Groundwater Transfer Review Summary Form

Transfer/PA # T- 14920

Application: T-14920

Applicant Name: Hope Village

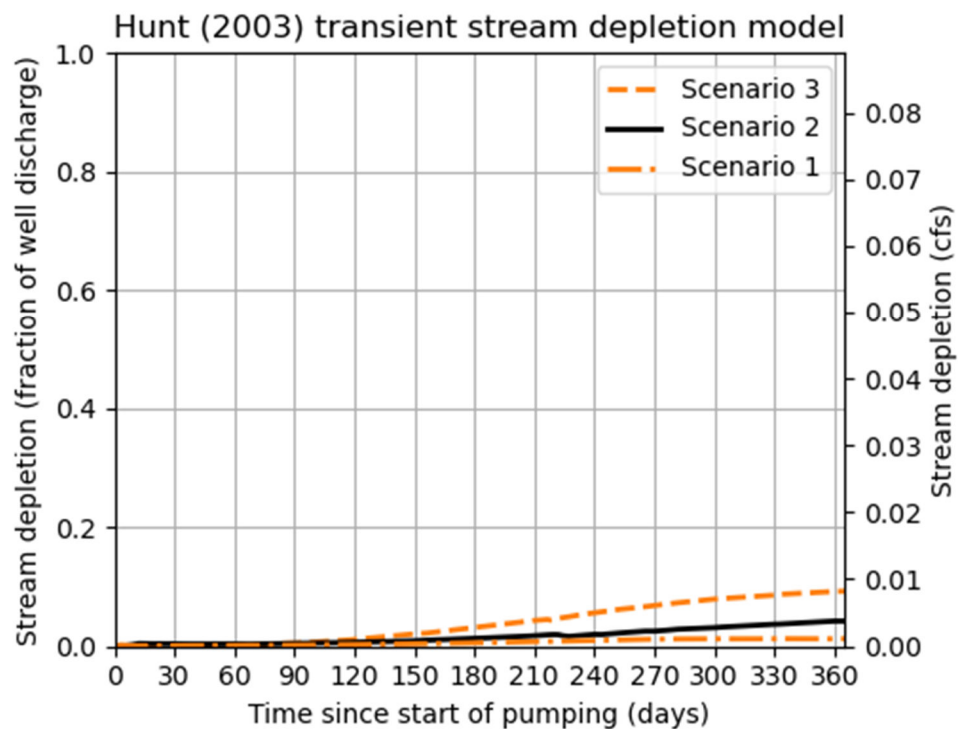
5. a) Will this proposed change, at its maximum allowed rate of use, likely result in an increase in interference with **another ground water right**?
☐ Yes ☐ No Comments: The nearest well was identified as CLAC 12906, a well used by City of Canby / Canby School District for school grounds irrigation. CLAC 12906 is approximately 1,800 feet northeast of authorized CLAC 52004 and approximately 1,700 feet northeast of proposed APOA Well 3. The reduced intervening distance may result in an increase in interference with CLAC 12906.

- b) If yes, would this proposed change, at its maximum allowed rate of use, likely result in another groundwater right not receiving the water to which it is legally entitled?
☐ Yes ☒ No If yes, explain: The relatively minor change in distance, along with the fact that none of the wells fully penetrate the 600- to 800-foot-deep Willamette Aquifer, indicate that there is minimal potential for the proposed change to result in injury.
